Technical Information Sheet

R233 water pump

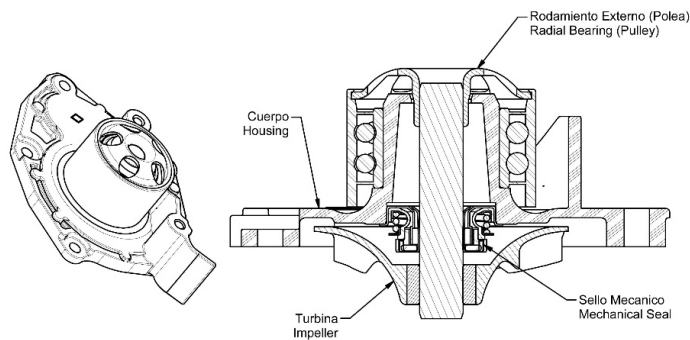
In order to improve the durability of the water pump that mounts on the Renault F9Q engines (1.9 Di-D, 1.9 dCi) used in Renault, Mitsubishi, Nissan, Volvo, Opel and Kia vehicles, we have developed the reinforced model R233 with a new structure.

This new water pump replaces our reference R219 in all its applications, but the R233 bearing is mounted on the outside of the body, instead of inside. This has allowed us to go from a 30mm diameter bearing with two rows of 6 balls in each one, to a 54.2mm bearing with two rows of 11 balls each. Thus we have increased the static and dynamic load capacity of the pump bearing more than 2.5 times, which reduces the possibility of bearing failure due to excessive timing belt tension.
